ADDENDUM NO. 2

To the Drawings and Project Manual dated 1 April 2019
for

MIDWESTERN STATE UNIVERSITY RENOVATIONS TO J.S. BRIDWELL HALL

Addendum Date: 17 May 2019

5 PARALLEL FAN POWERED VAV TERMINAL BOX
SCALE: NO SCALE

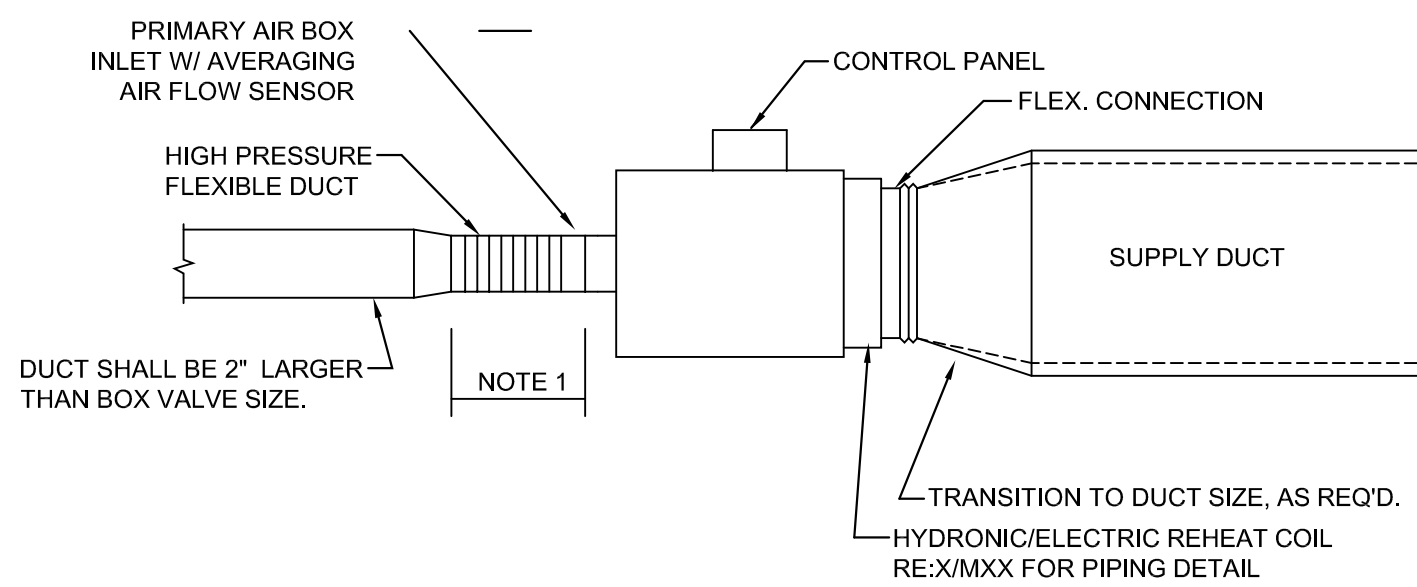
ADD: As clarification, Sheet “**M6.2**” has been added to the Mechanical Drawings and Construction Documents to depict an added Mechanical detail.

ADDENDUM #1 NOTE:
NEW SHEET.

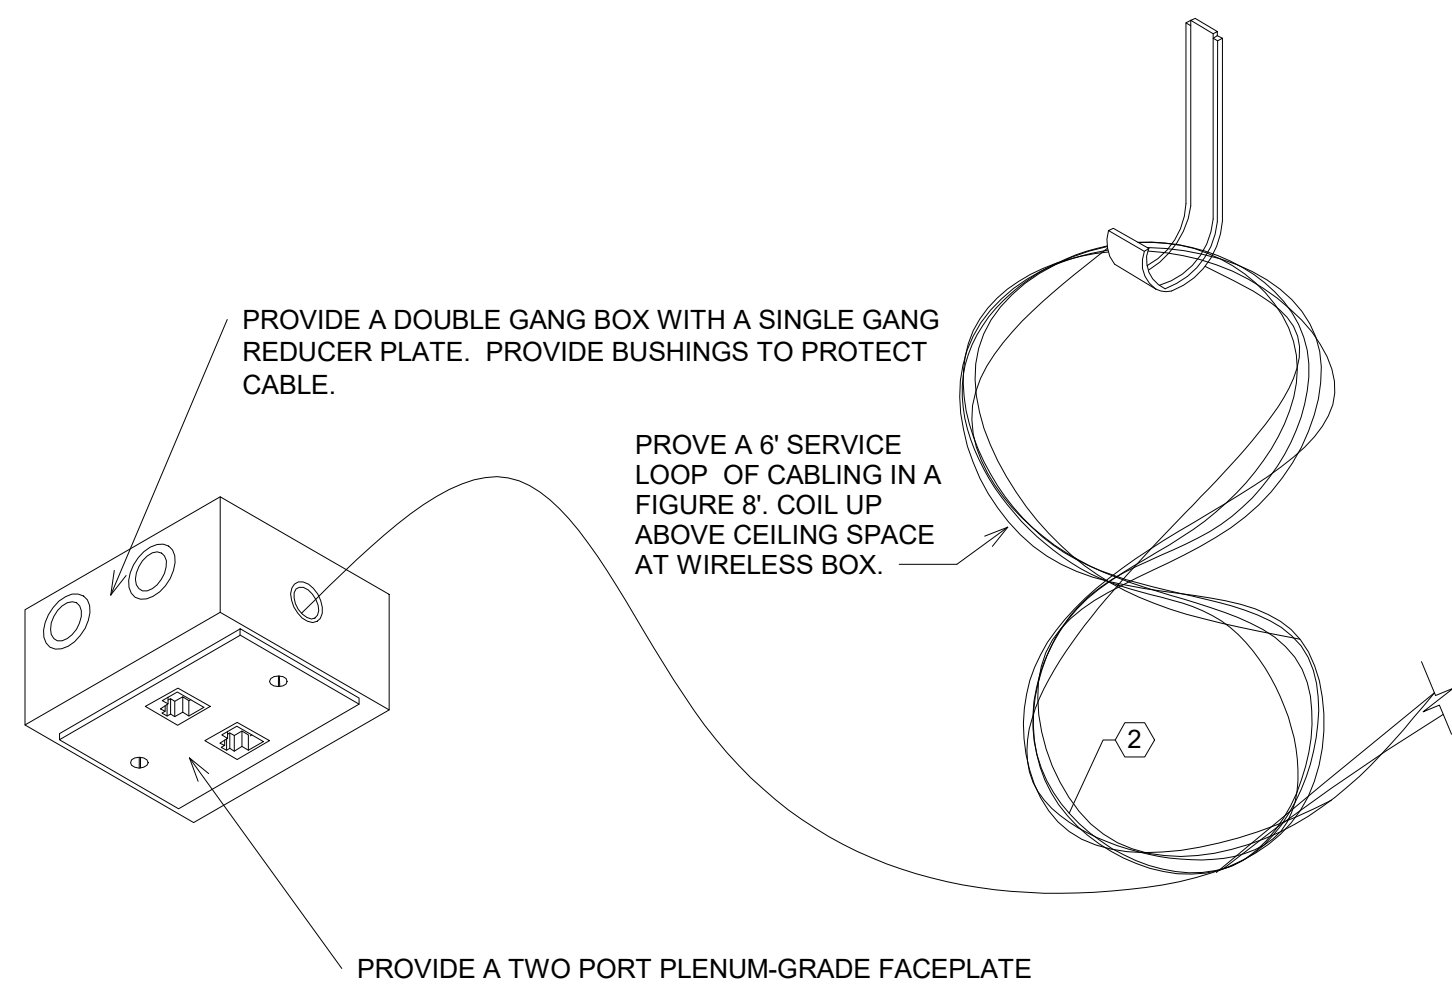
ADD: As clarification, Sheets “**TO.1**”, “**TO.2**”, “**T1.1**”, “**T1.2**”, “**T1.3**”, “**T2.1**”, “**T2.2**” and “**T2.3**” have been added to the Electrical Drawings and Construction Documents. These drawings were added to help clarify the scope of work included in Alternate **#4**, Information Technology Infrastructure Upgrades.

FIRST FLOOR MEDICAL GAS DEMOLITION PLAN

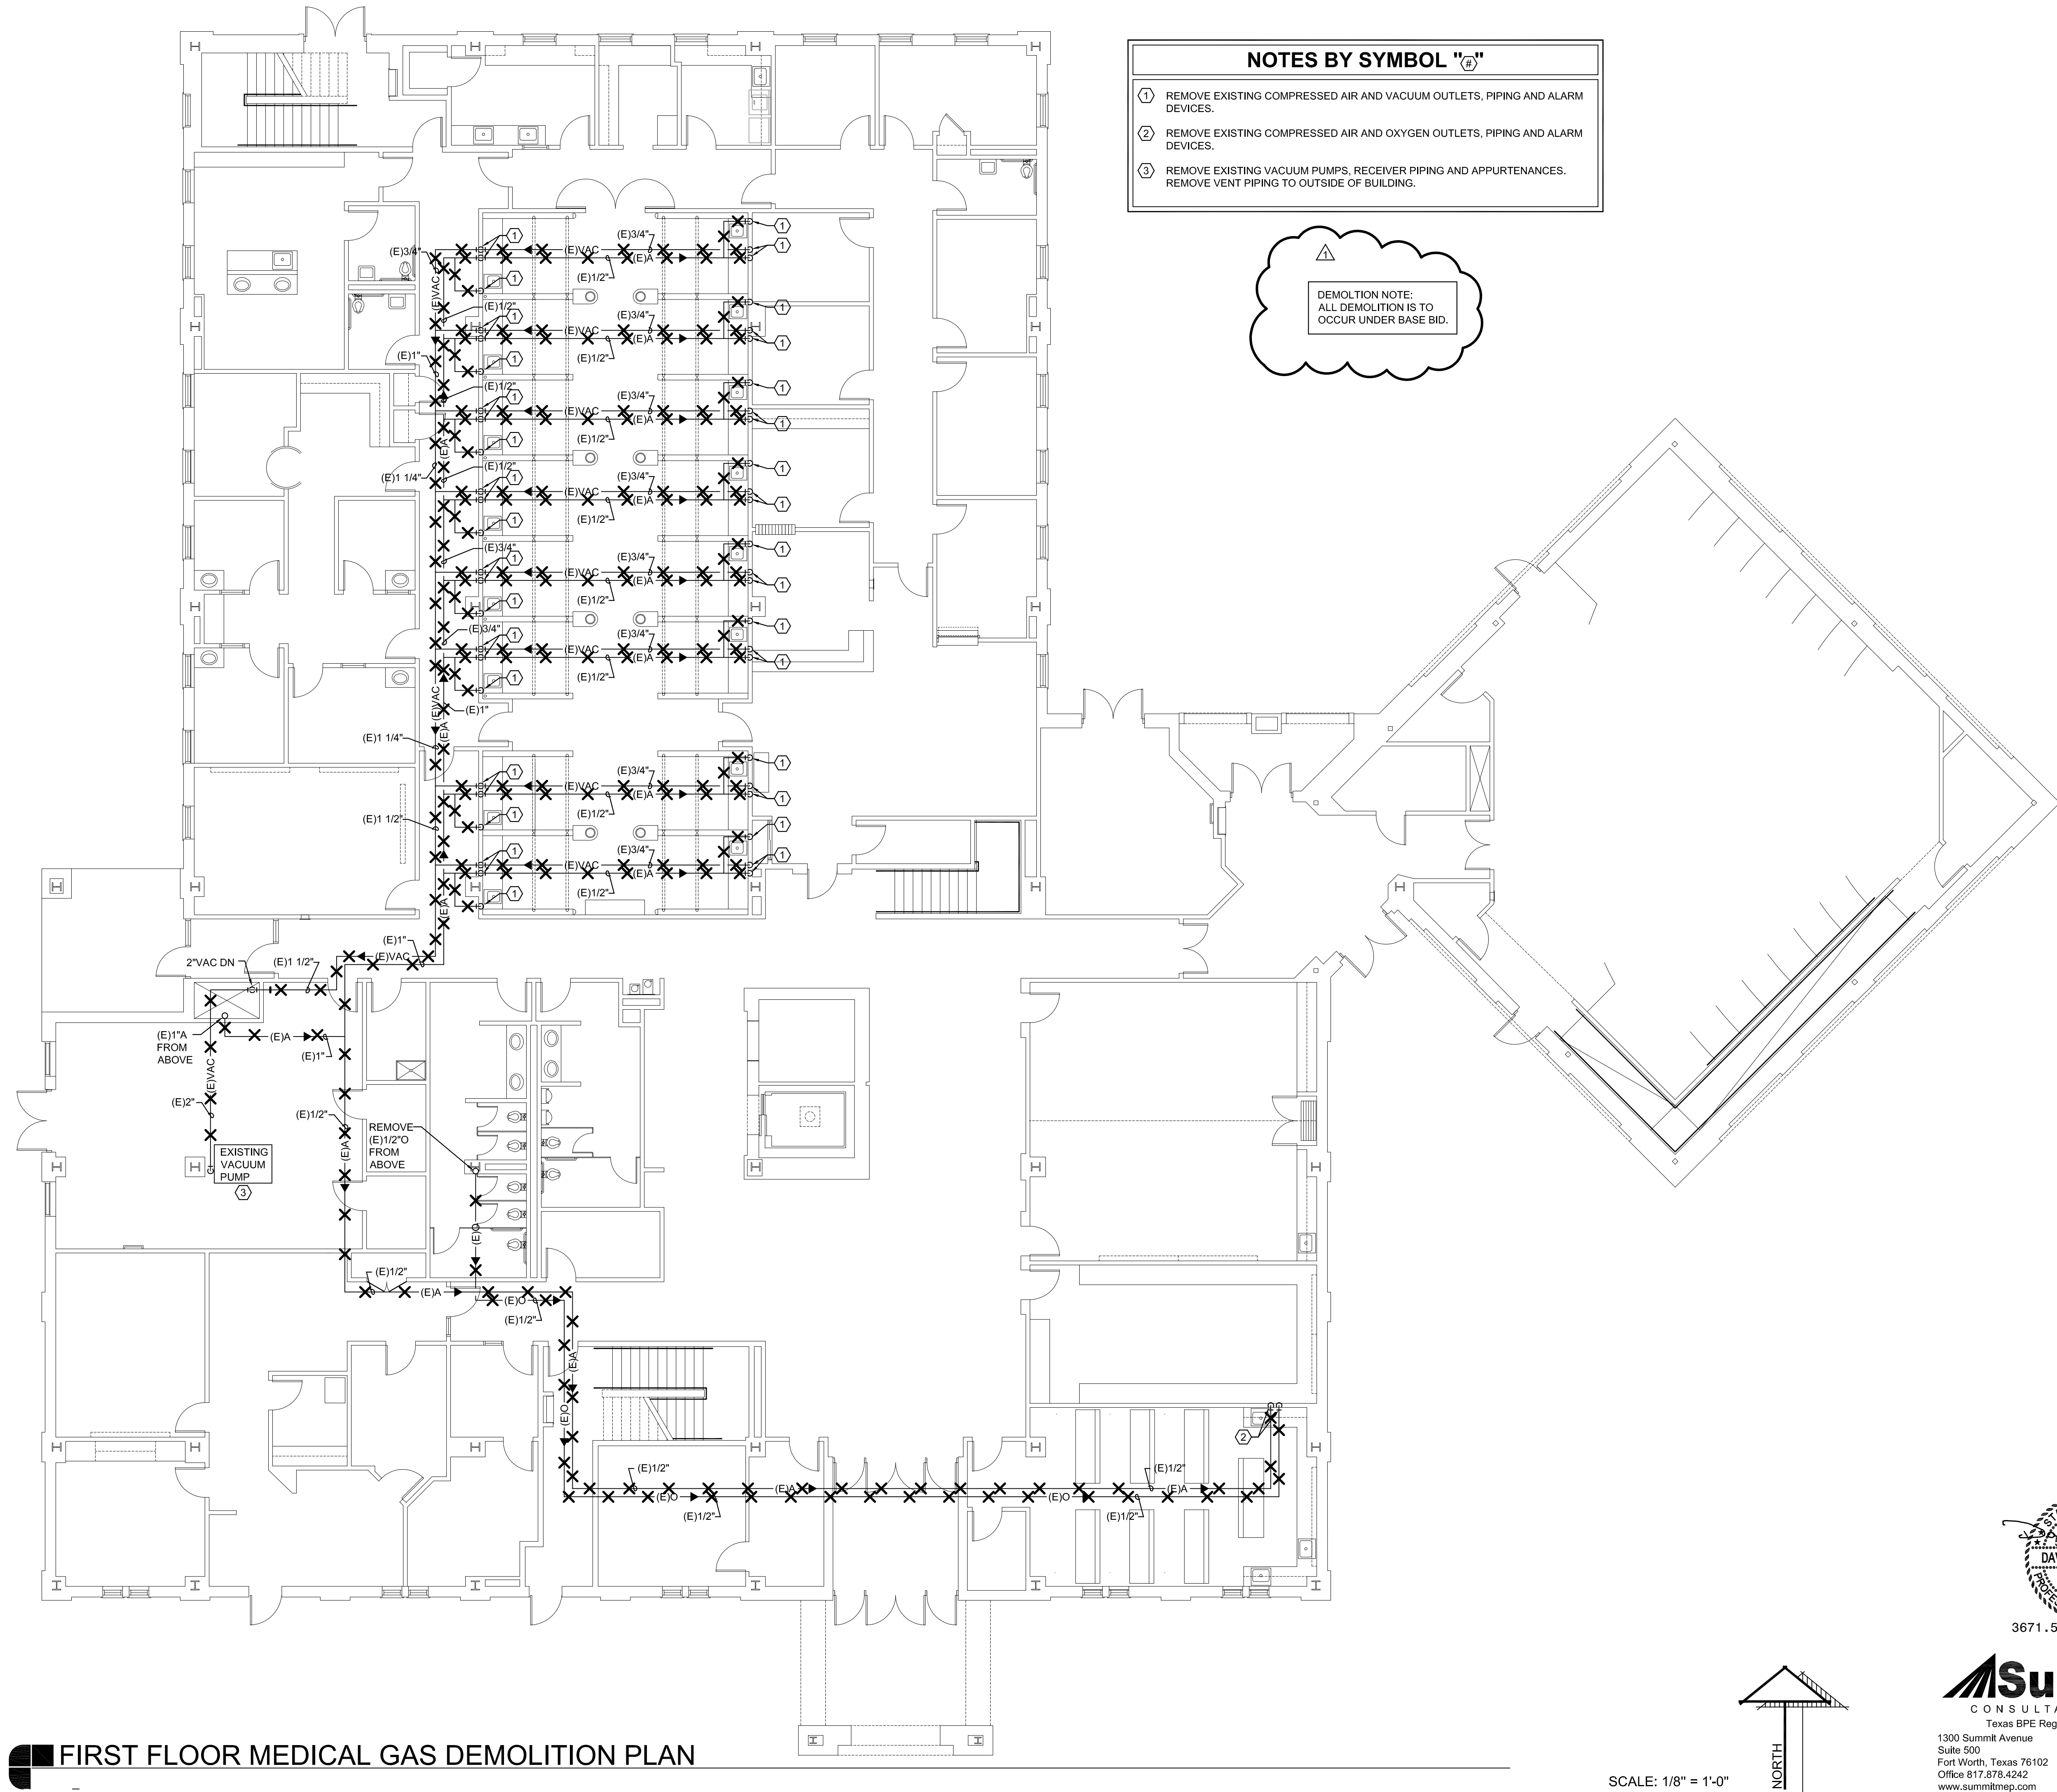
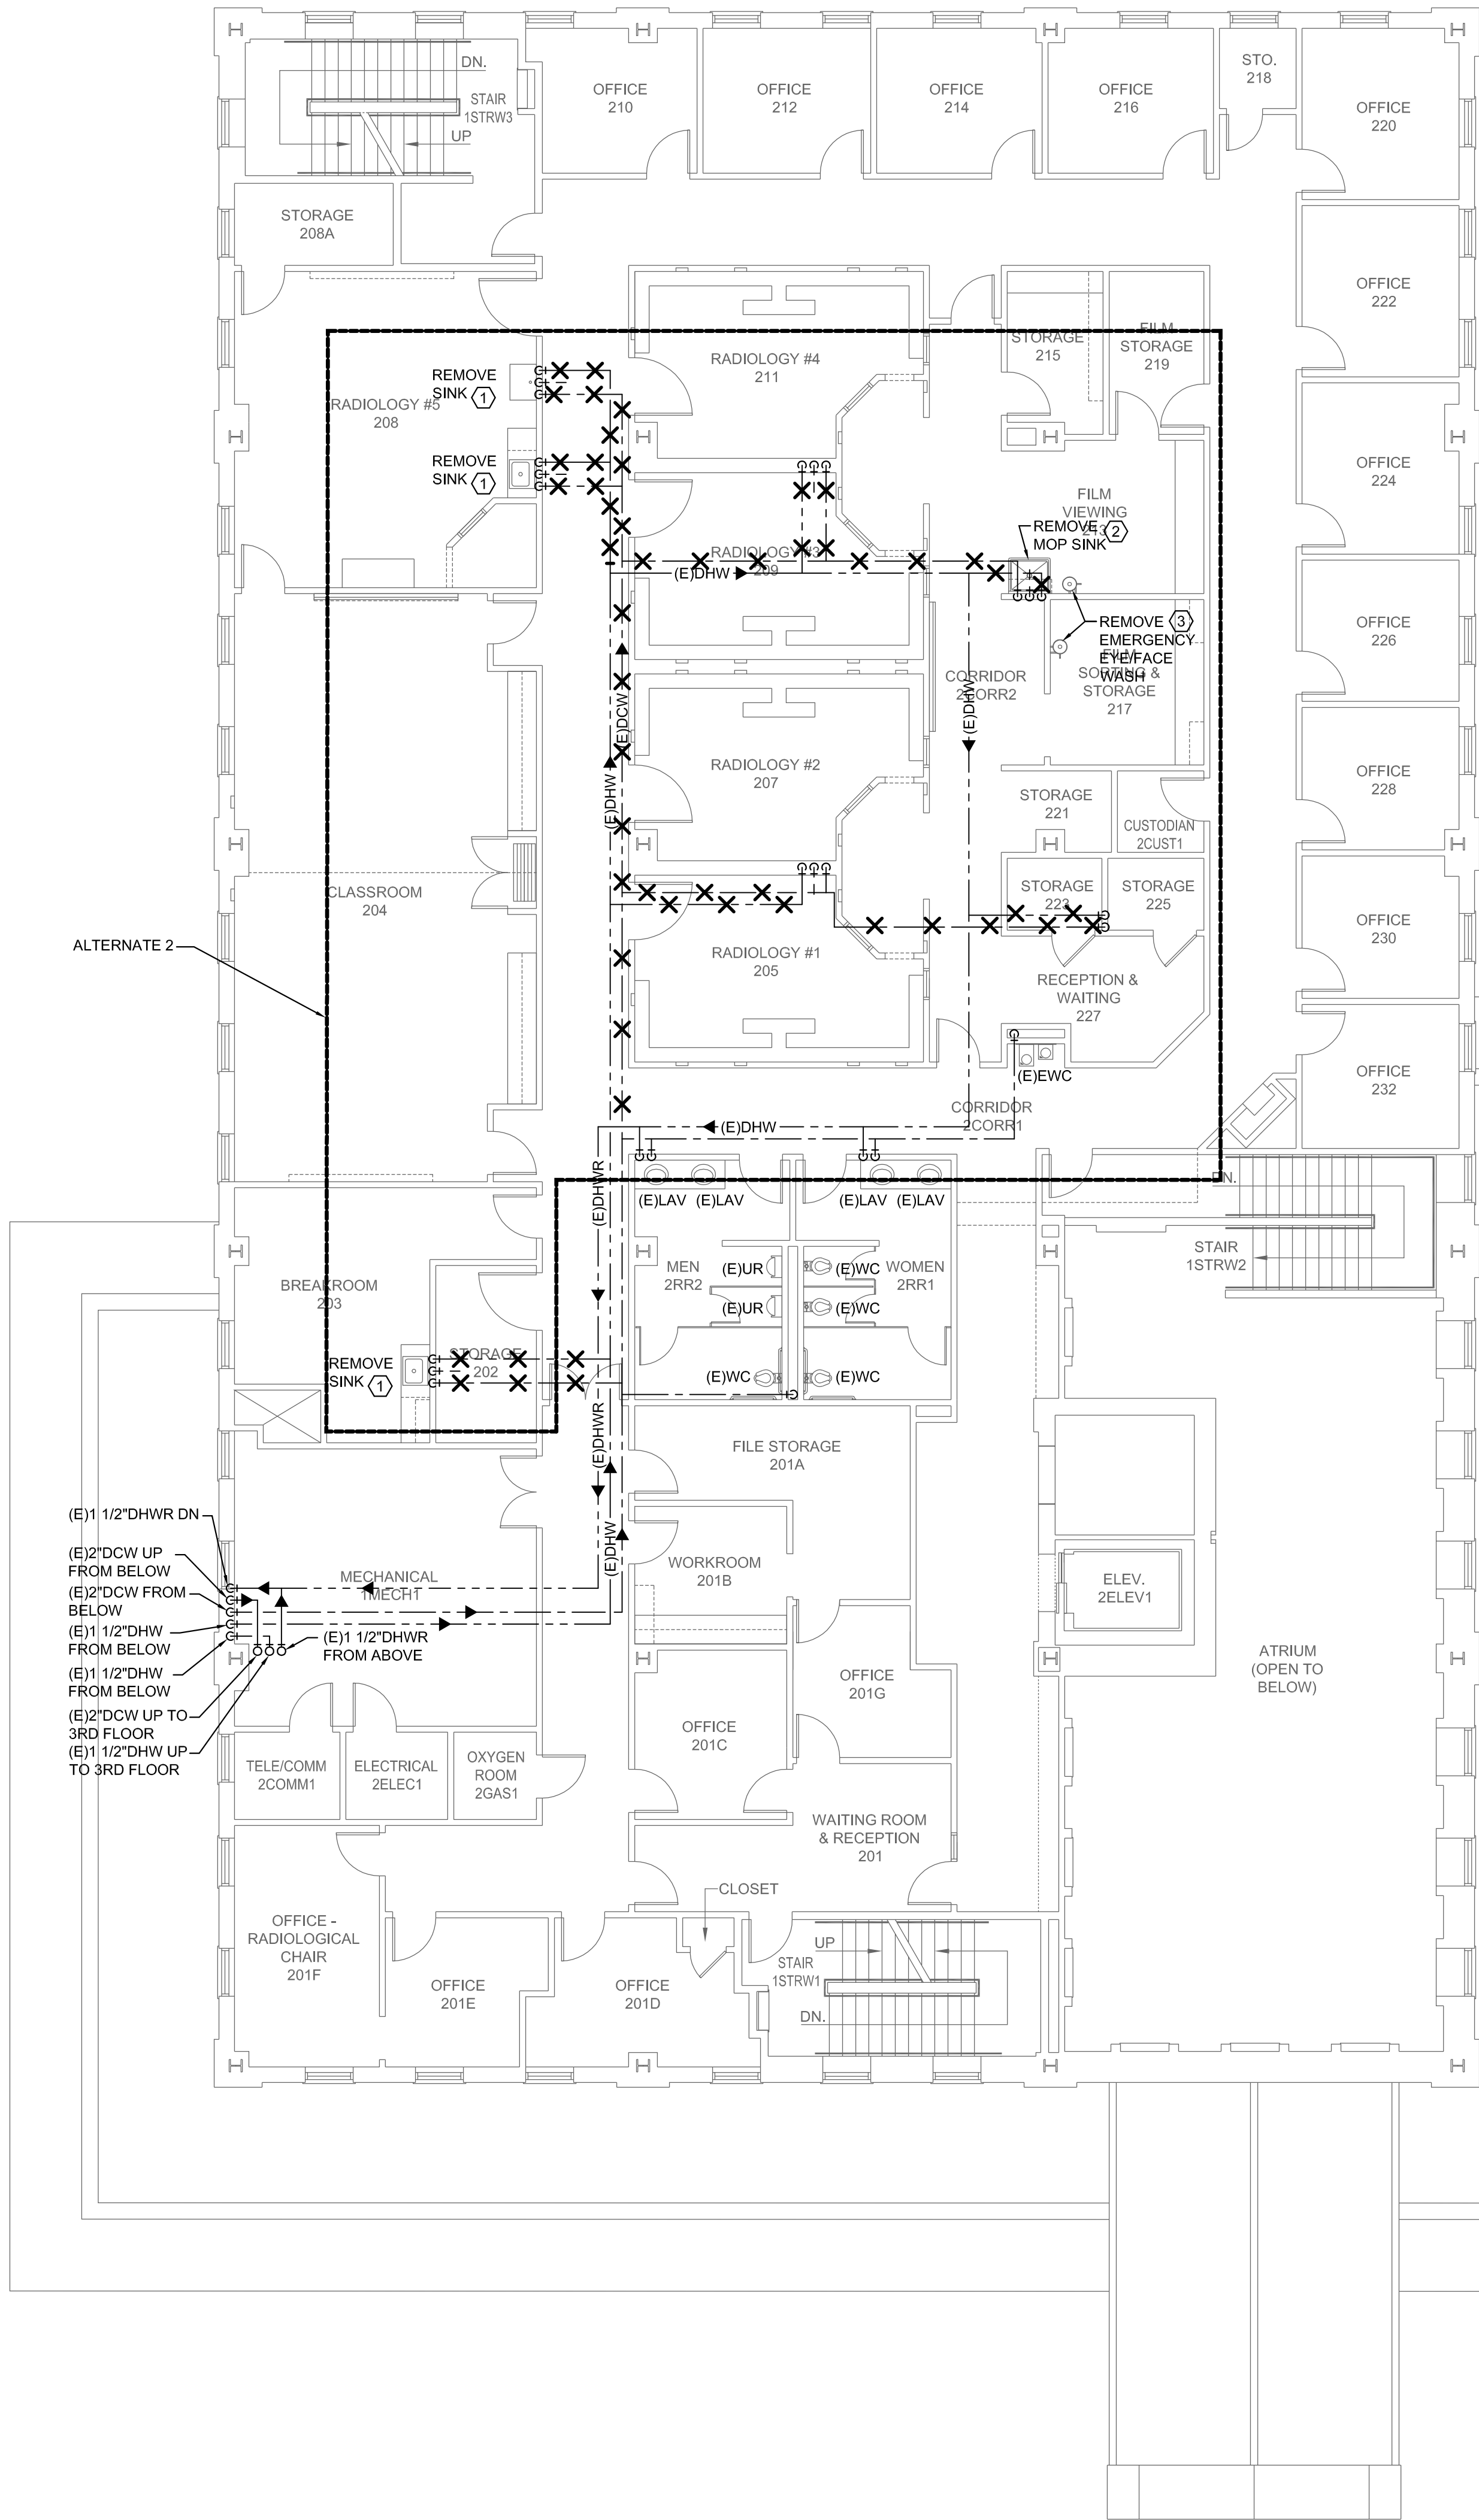
ITEM 4 - AD#2: To the Drawings, Sheet “**P101b**”, “**First Floor Medical Gas Demolition Plan**”; and Sheet “**A101**”, “**First Floor Plan – New**”.

ADD: As clarification, there are existing medical gas lines (compressed air, vacuum outlets, etc.) that are being removed as part of this Project. All wall penetrations, voids, and former outlet box locations shall be infilled with matching wall material (most are drywalls) and finished as per the **FINISH SCHEDULE** in Section **099900** in the Project Manual.
